# ADDENDUM NO. 06

**October 6, 2023**

**Northwestern School Corporation – Multiple Projects**  
**3431 County Rd N 400 W**  
**Kokomo, IN 46901**

PREPARED BY SCHMIDT ASSOCIATES FOR:  
**NORTHWESTERN TIGERS BUILDING UPDATES**  
**NORTHWESTERN (HOWARD) SCHOOL CORPORATION**

##### A. Drawing Number 1-AD1A1

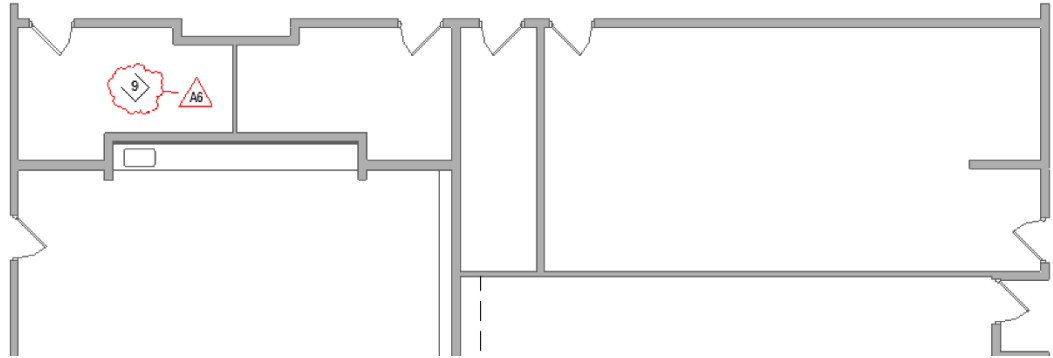
1. ADD Note 12 as follows:

2. ADD Note 9 as follows:

3. DELETE Note 9 as follows: From room A115 (MAIL & WORK ROOM)

**B. Drawing Number 1-AD1B1**

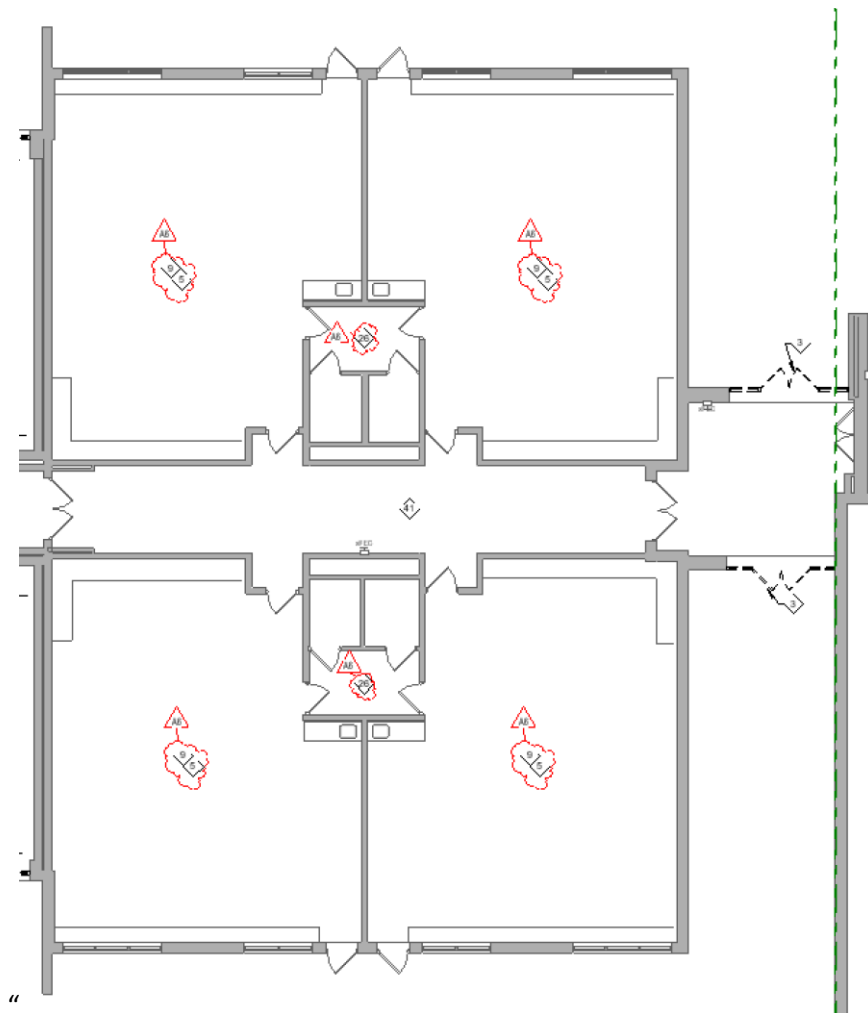
1. ADD Notes 9 AND 26 as follows:

**C. Drawing Number 1-AD1D1**

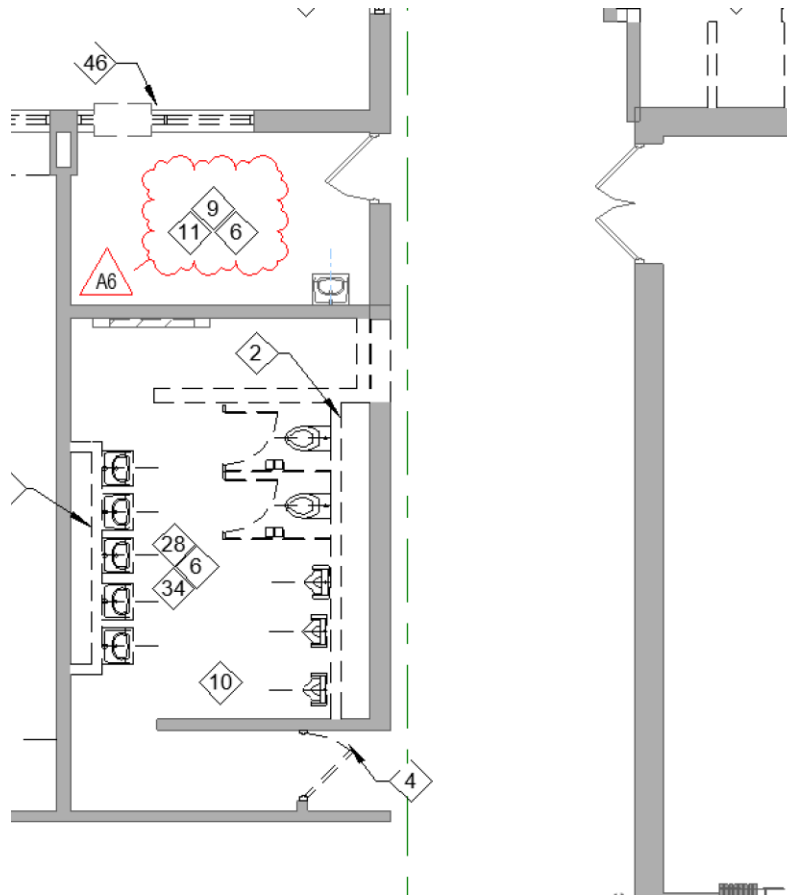
1. ADD Note 6, 9 and 11 as follows:

**D. Drawing Number 2-AD1B1**

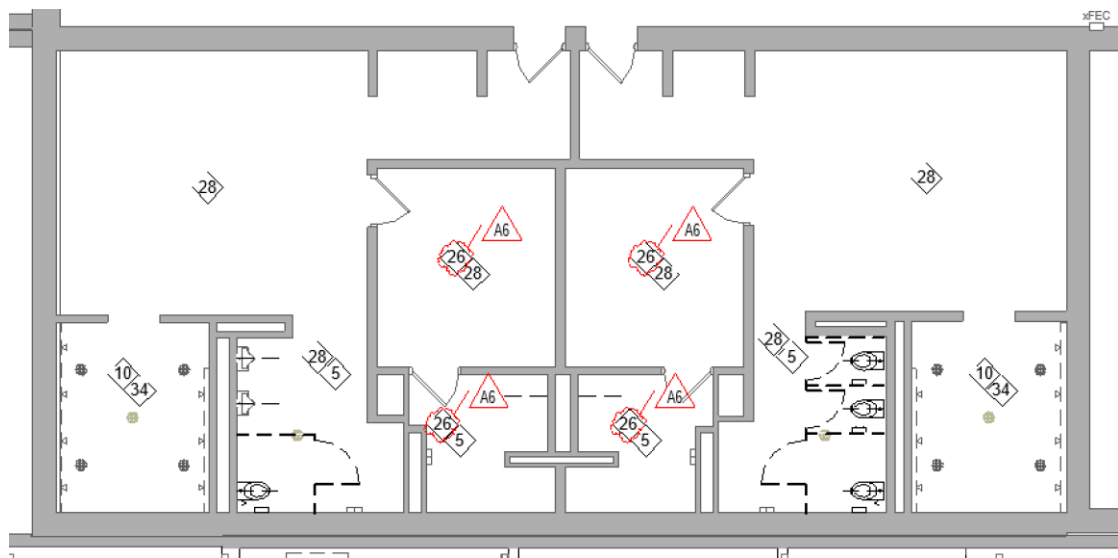
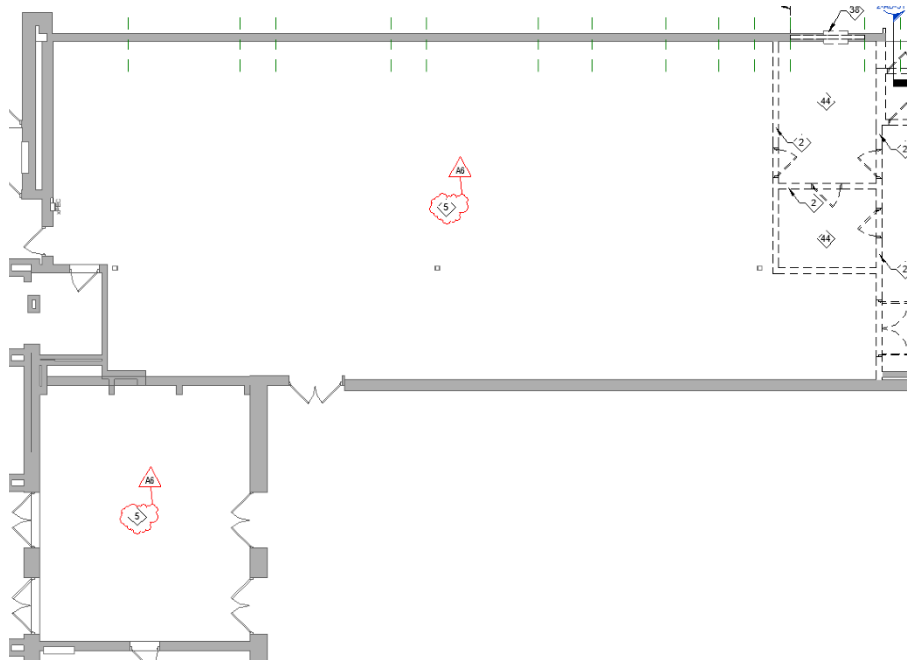
1. ADD Note 26 as follows:

E. Drawing Number 2-AD1C1

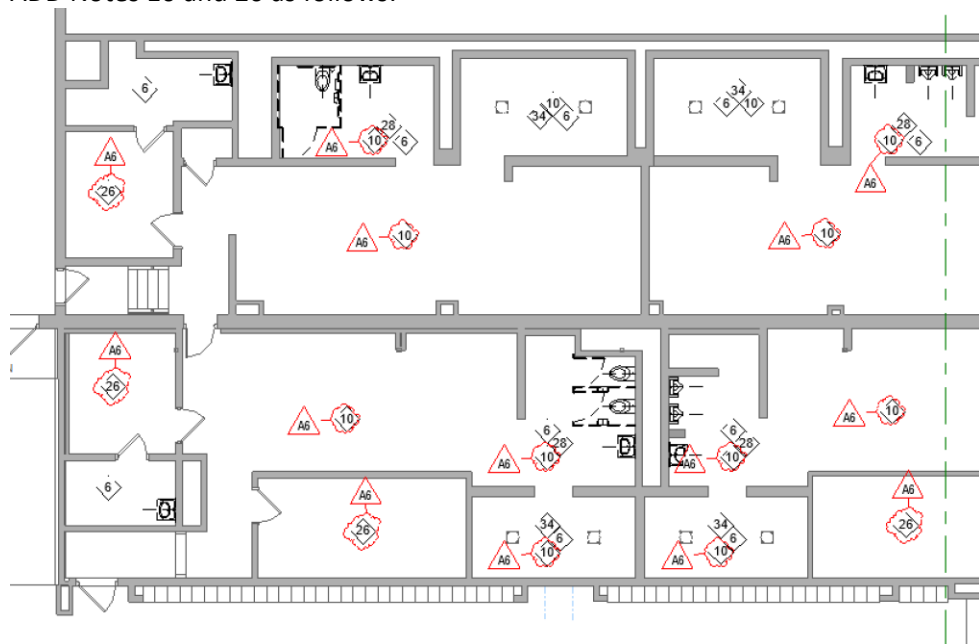
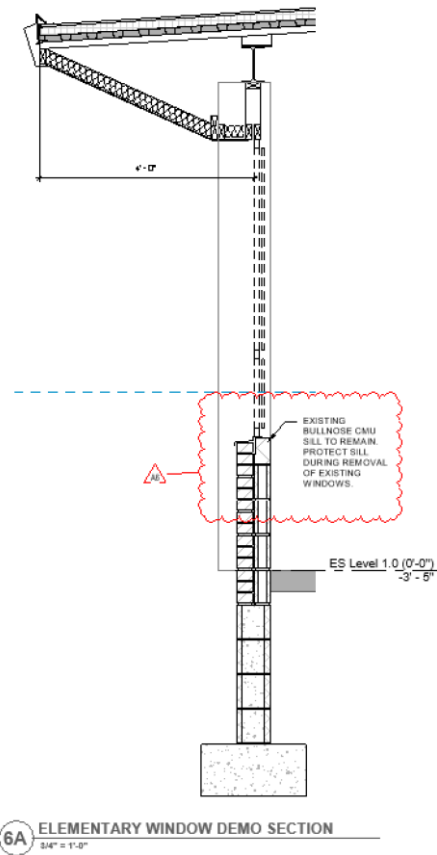
1. ADD Note 5 as follows:
2. ADD Notes 10 and 26 as follows:

3. MODIFY Detail 6A/ 1AD1C1 as follows:

**F. Drawing Number 2-AD1D1**

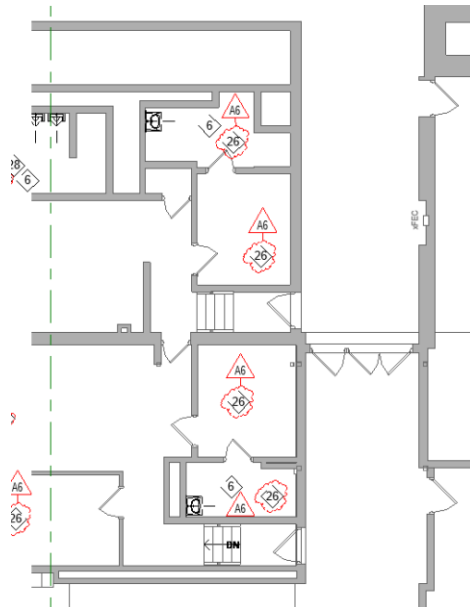
1. ADD Note 26 as follows:

**G. Drawing Number 2-AD1F1**

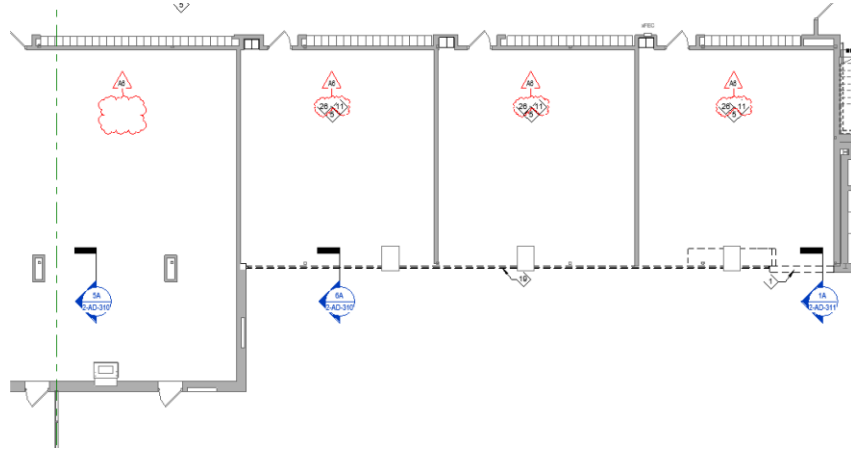
1. ADD Notes 11 and 26 per the attached.
2. DELETE Note 5 from room G142

**H. Drawing Number 2-AD1G1**

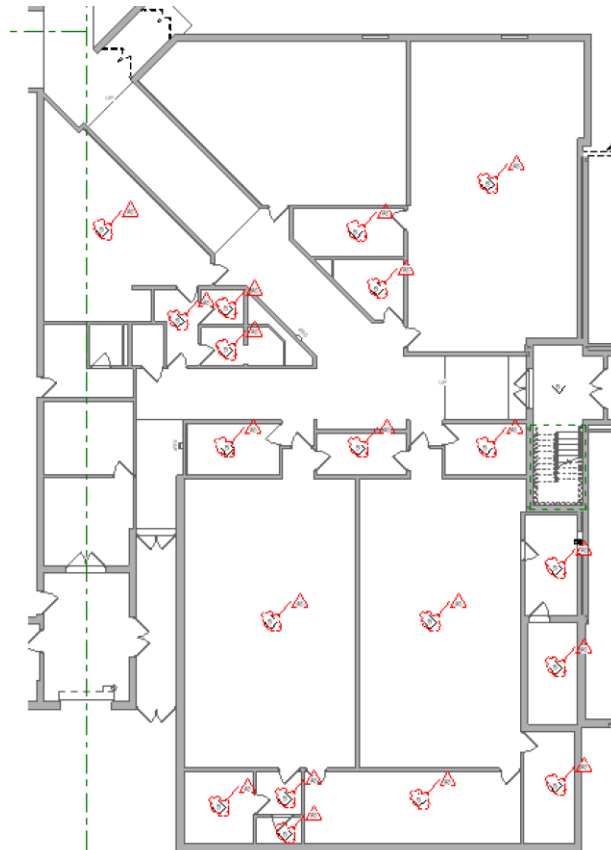
1. DELETE Note 5 from rooms G142 and G144 and associated rooms.
2. ADD Note 5 as follows:

**I. Drawing Number 2-AD1K1**

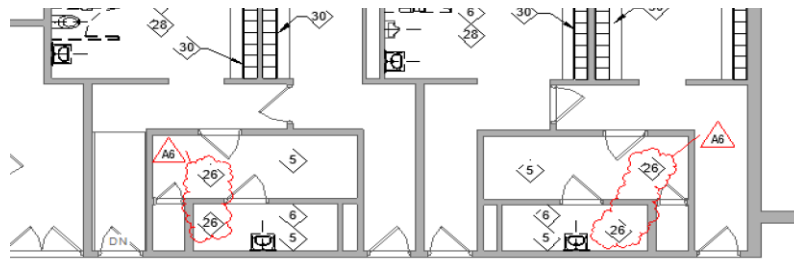
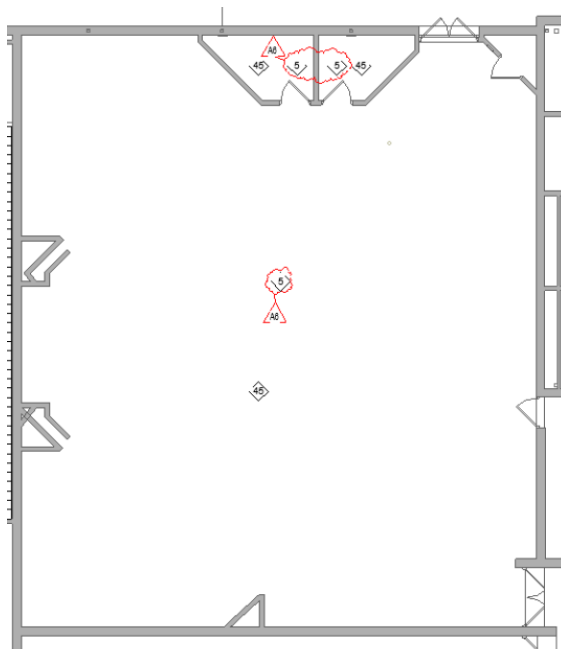
1. ADD Note 26 as follows:

2. ADD Note 5 as follows:

**J. Drawing Number 2-AD1J1**

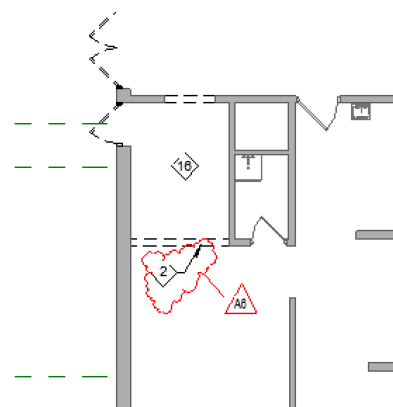
1. MODIFY Plan as follows:

**K. Drawing Number 2-AD1F2**

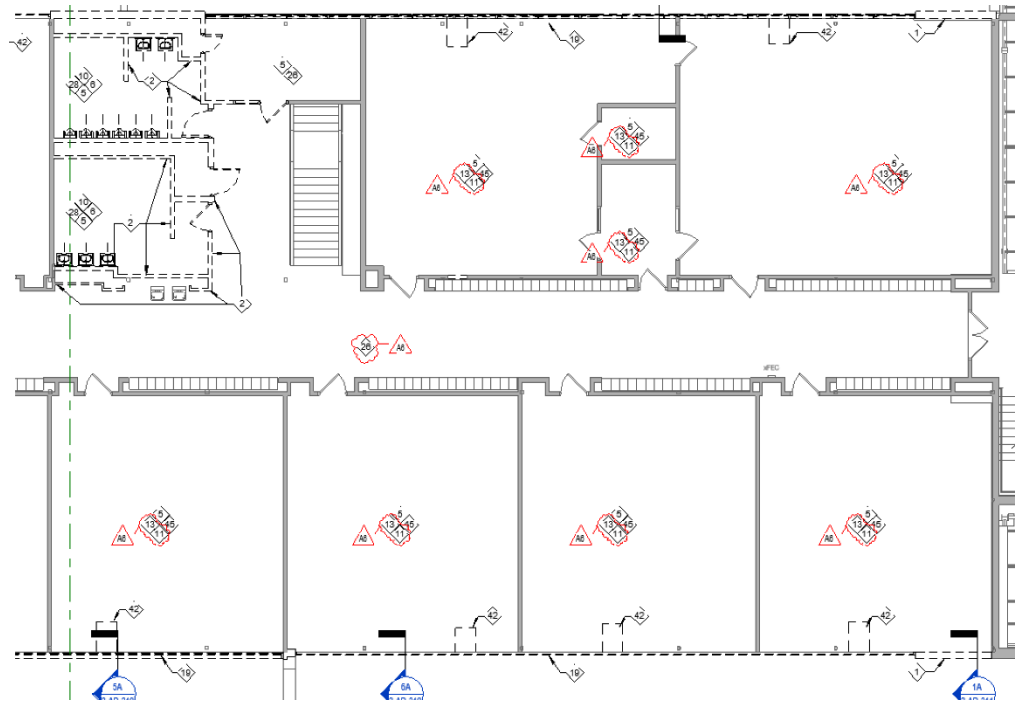
1. ADD Notes 11, 13, and 26 as follows:

**L. Drawing Number 2-AD1G2**

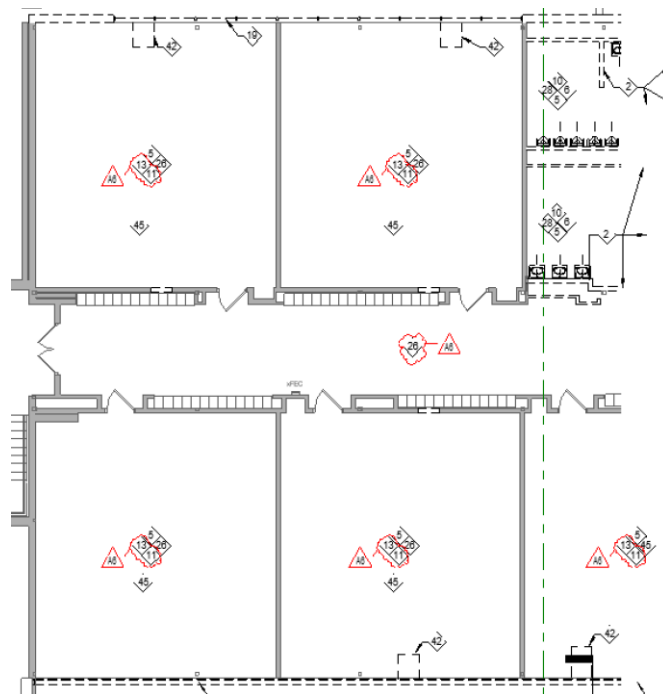
1. ADD Notes 11, 13, and 26 as follows:

**M. Drawing Number 2-AF1K1**

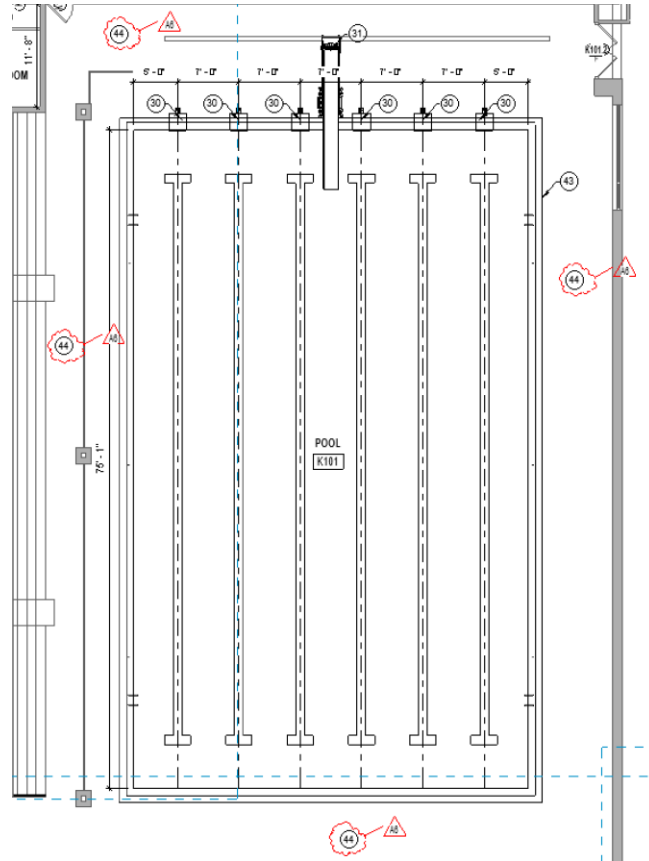
1. ADD Notes 44 as follows:

"033000 INFILL EXISTING RECESSED SLAB TO MATCH ADJACENT EXISTING SLAB ELEVATIONS. PREP FOR NEW FLOOR FINISH."

**N. Drawing Number 2-AC1A1**

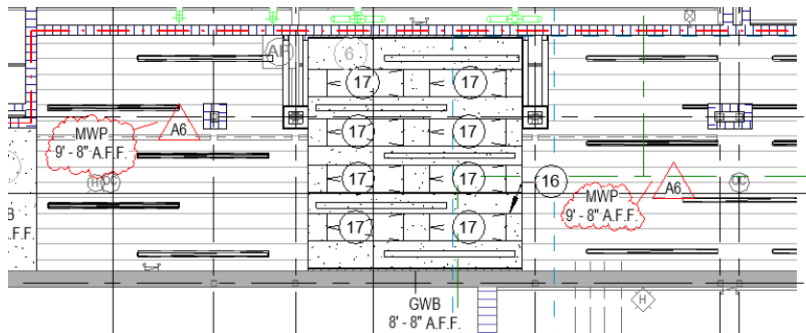
1. MODIFY Plan as follows:

**O. Drawing Number 2-AC1B1**

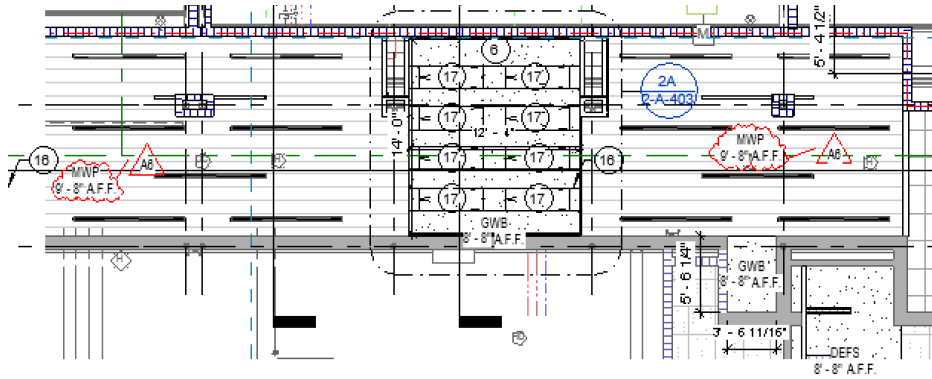
1. MODIFY Plan as follows:

**P. Drawing Number 2-AC1C1**

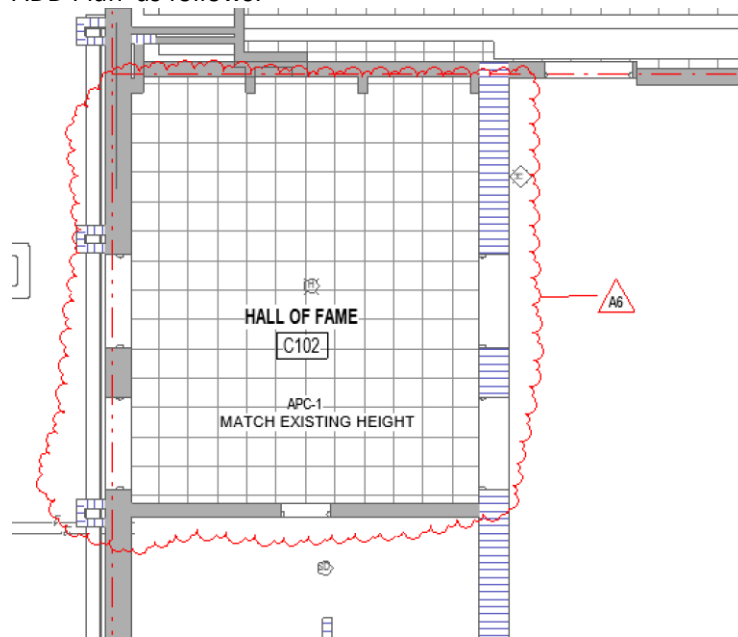
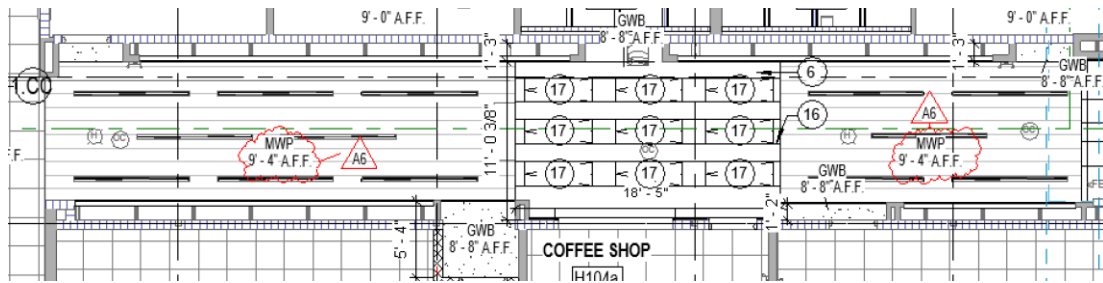
1. ADD Plan as follows:

2. ADD Plan as follows:

**R. Drawing Number 2-AC1L2**

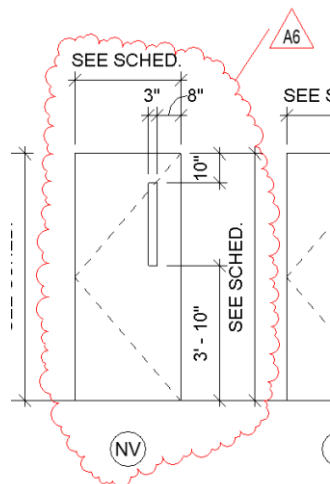
1. MODIFY Sketch as follows:

**T. Drawing Number 2-A-600**

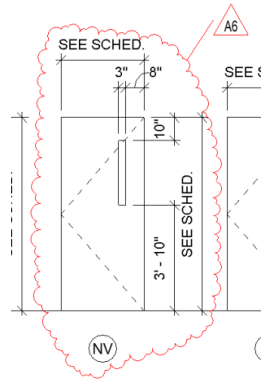
1. MODIFY Door Schedule door and frame material as follows:  
“Change the following doors and frame material to Aluminum”  
A116.2, B116.1, D147.2, D150.3, K001.1, K116.2, and L008.1
2. MODIFY Schedule as follows:  
Door D150.3 to have DG door panels
3. MODIFY Schedule as follows:

Door J101a width to be 3'-6"

4. MODIFY Detail as follows:

**U. Drawing Number 3-AD1A2**

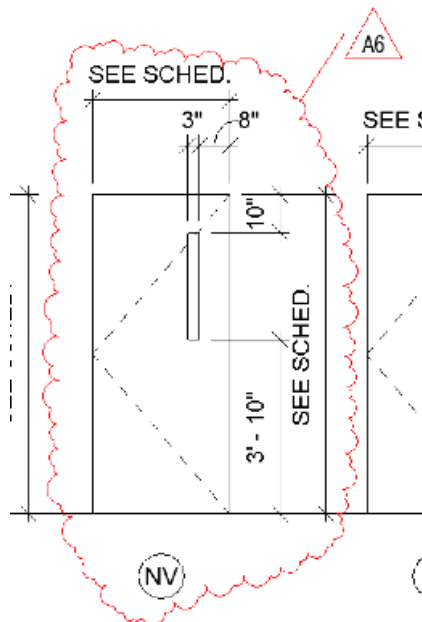
1. ADD Note 9 as follows:

"Add note 9 to all classrooms and corridors on sheet 3-AD1A2."

**W. Drawing Number 2-A-500**

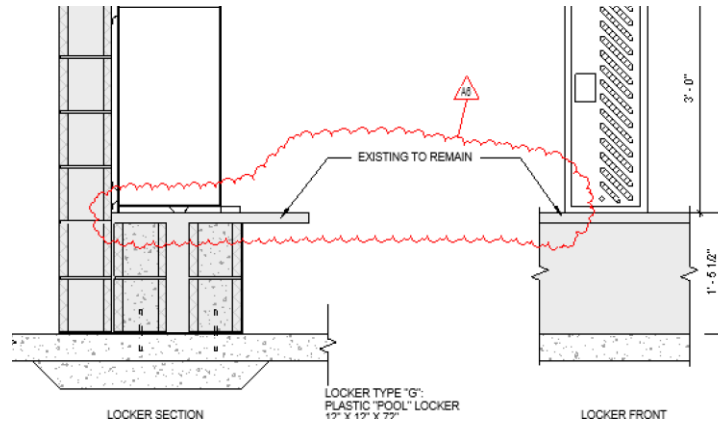
1. ADD Sketch as follows:

**M. Drawing Number 3-IP1A1**

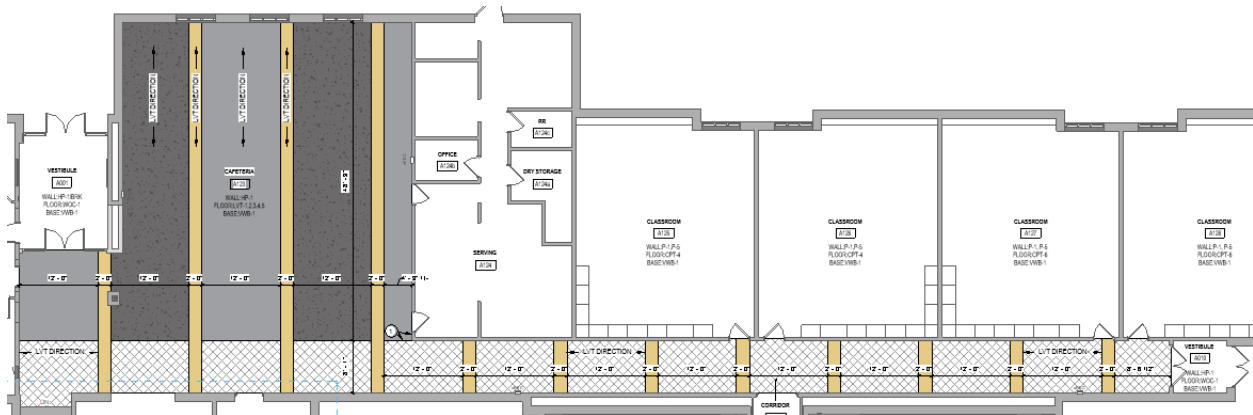
1. MODIFY Drawing replace the purple LVT-5 with they yellow LVT-4 in rooms A123 CAFETERIA and A009 CORRIDOR as follows:
